DOCKET NO. 70-139

EXHIBIT 'C'

G-2 QUANTITY	G-1 ITEM NO.	ITEM NO.	DRAWING NO.	DESCRIPTION	PROJECT NO.	USED ON ASS'Y
TOLERANCES UNLESS OTHERWISE SPECIFIED				APPROVED	DATE	FINISH & SPECIFICATION
DECIMAL ±.005				DRAWN <i>[Signature]</i>	12-28-59	MATERIAL & SPECIFICATION
FRACTIONAL ±1/64"				CHECKED		
ANGULAR ± 1/2°				APPROVED <i>N. Weiss</i>	12-28-59	
BREAK ALL SHARP EDGES				ENGELHARD INDUSTRIES, INC.		SCALE
REMOVE ALL BURRS				D. E. MAKEPEACE DIVISION		NONE
				SIZE	DRAWING NO.	REV.
				C	50034	A
				TITLE		
				STORAGE RACKS FOR FINISHED PINS

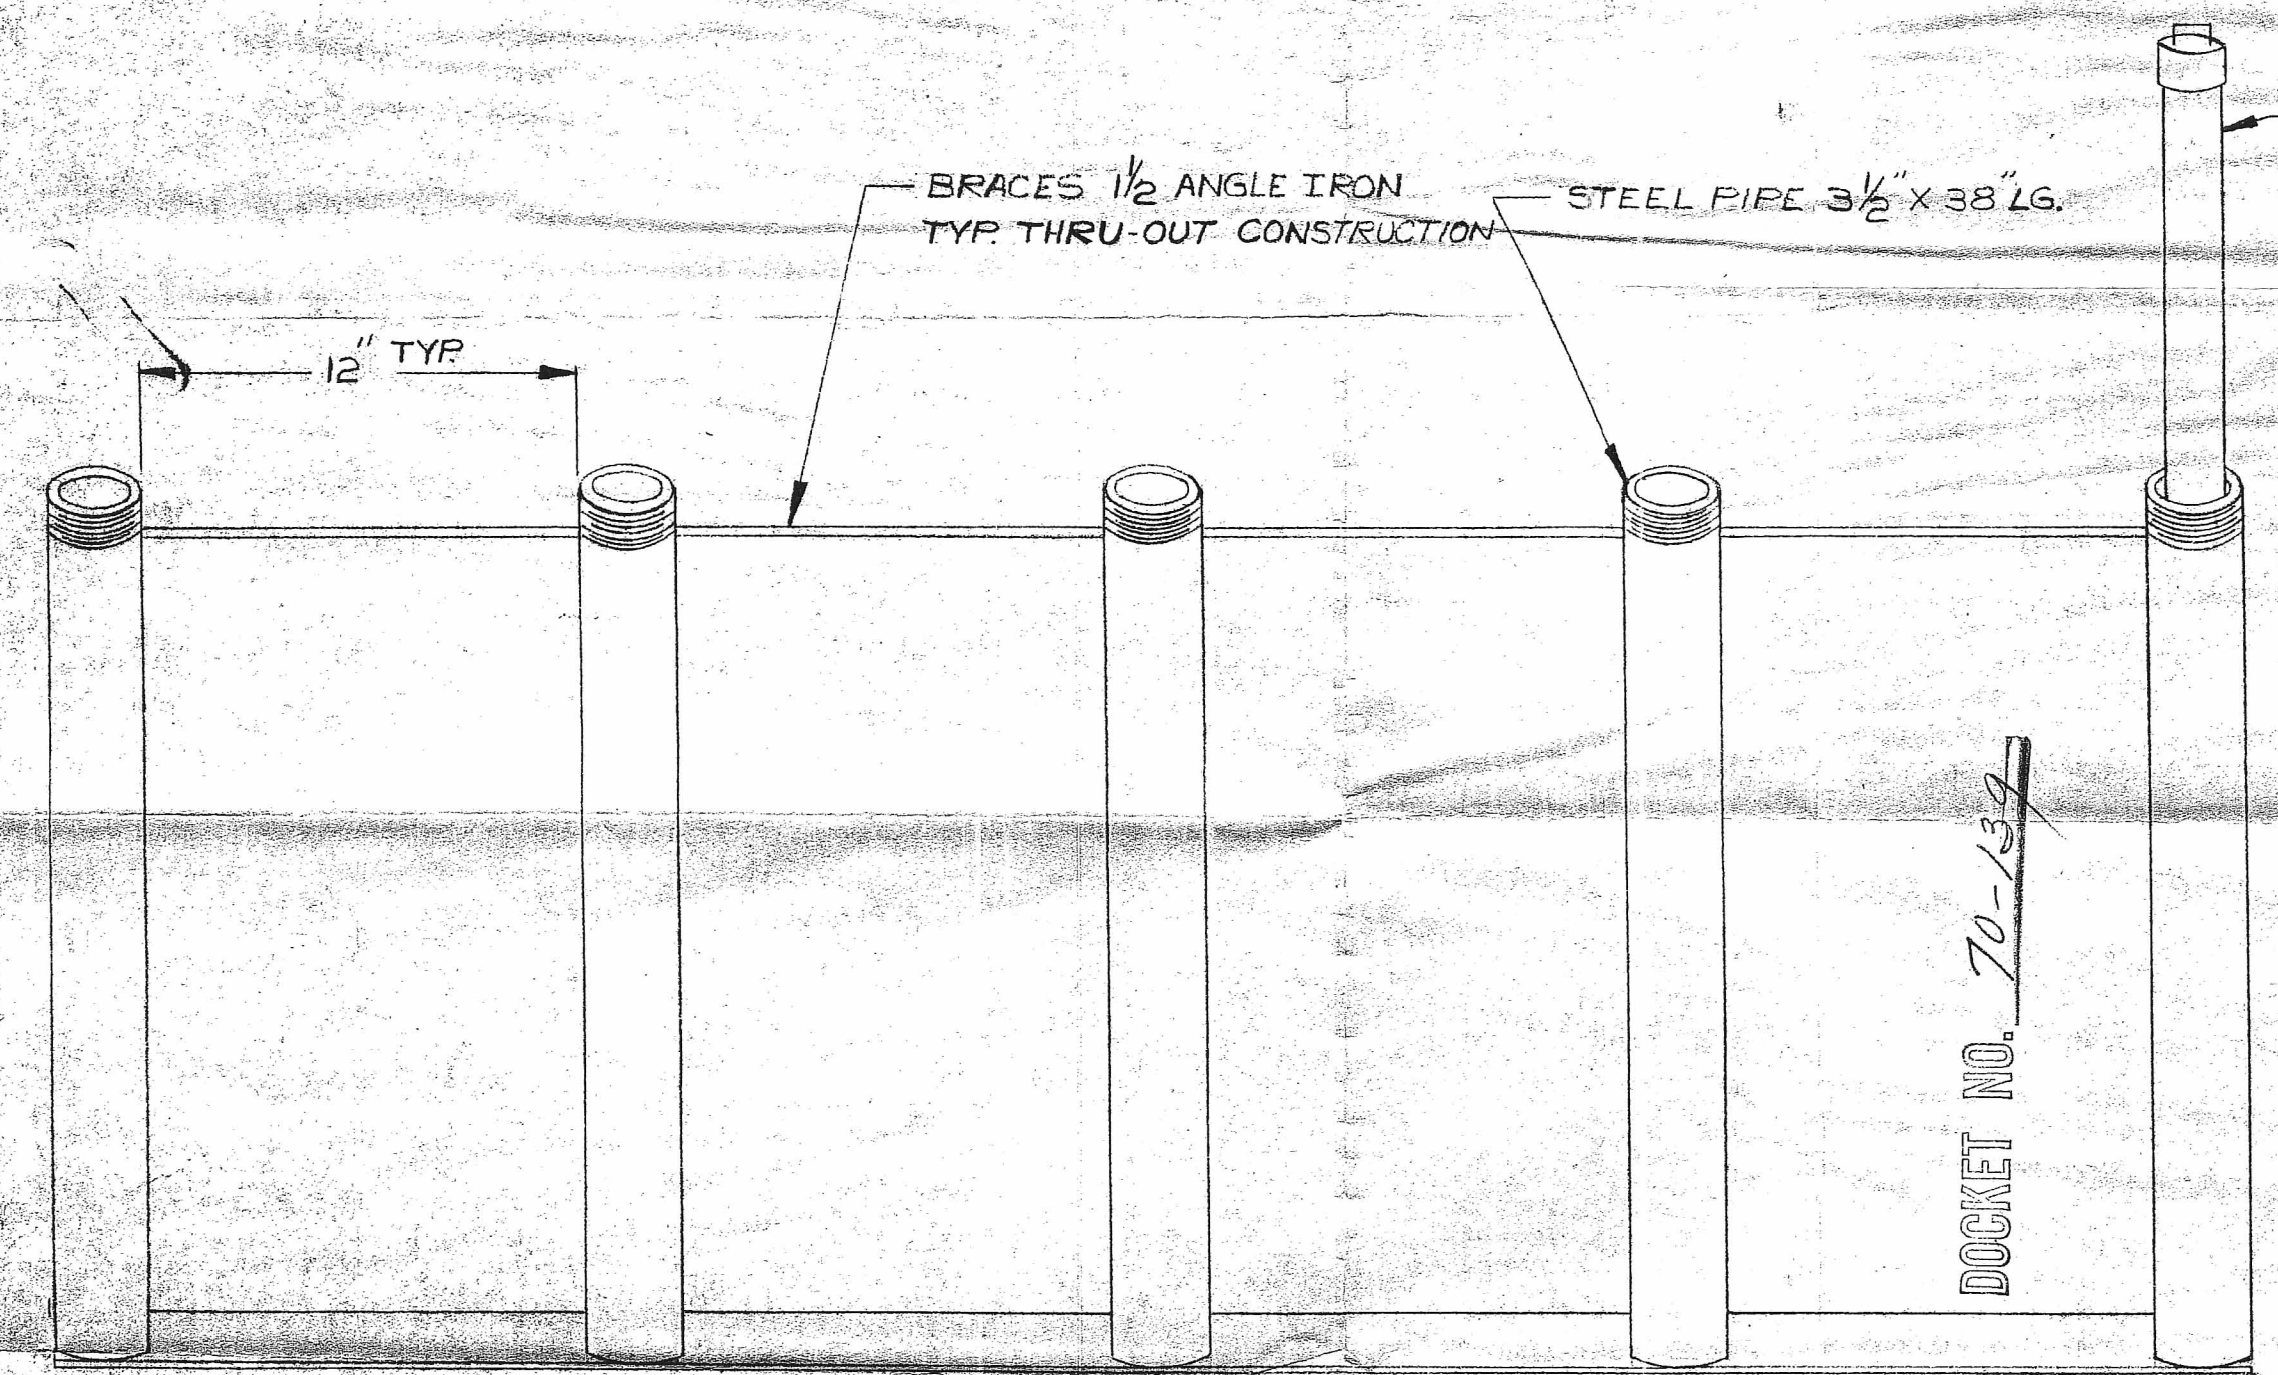
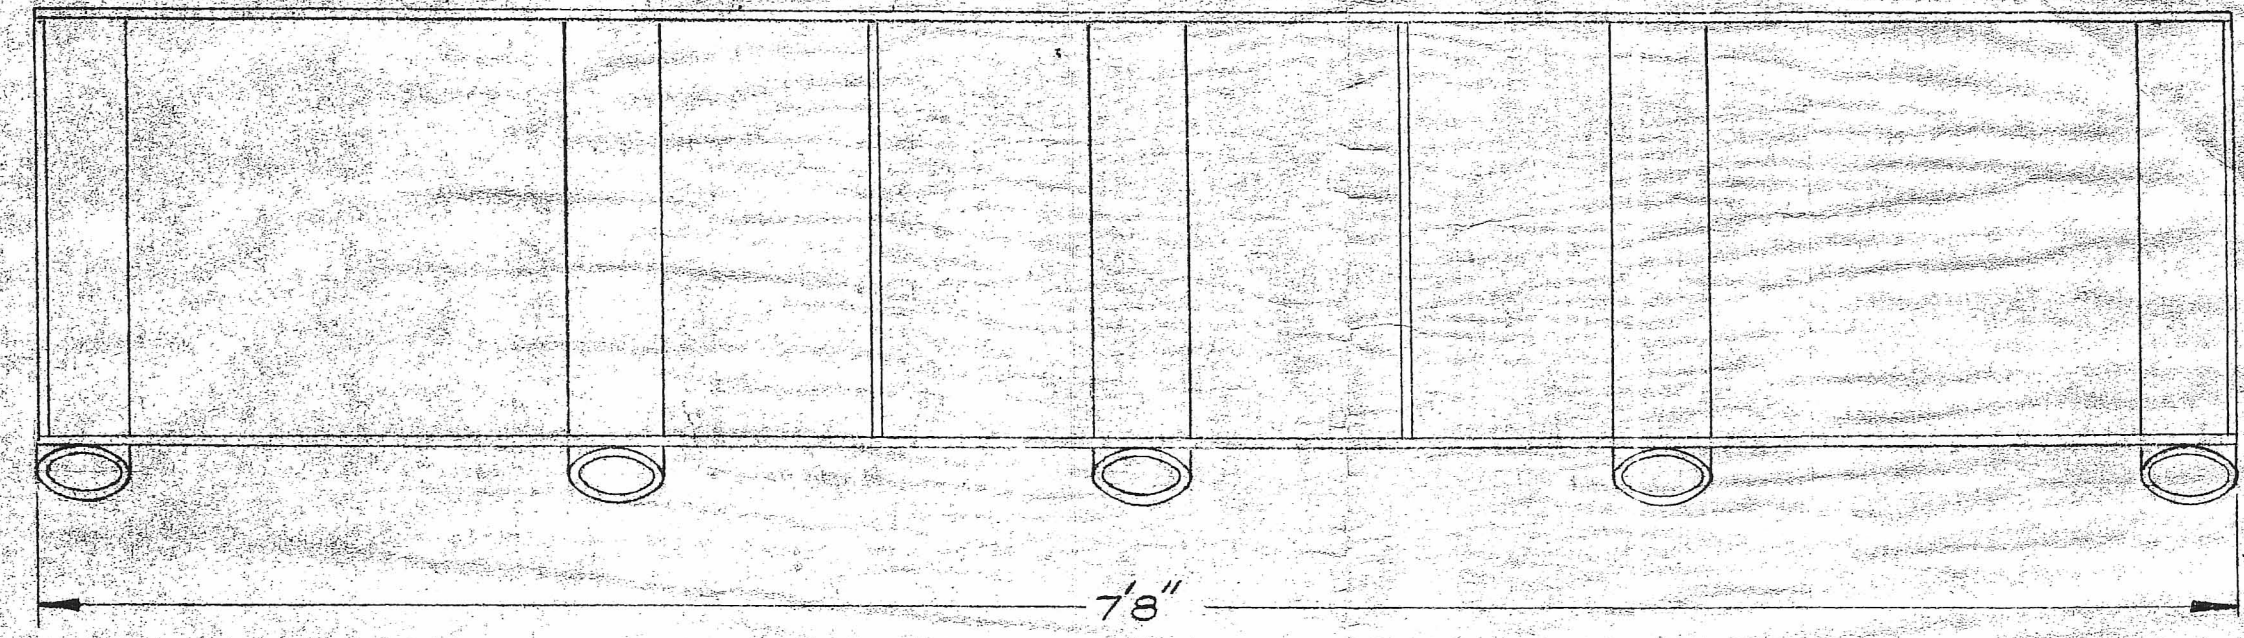
CHG. LET.	DESCRIPTION	DATE	BY	APP.	CHG. NO.
A	REMOVED CADMIUM LINER CHANGE TUBE SPACING TO 12" CHANGE BRACE FOR FLOOR MOUNTING	3/10/60	AJF		197
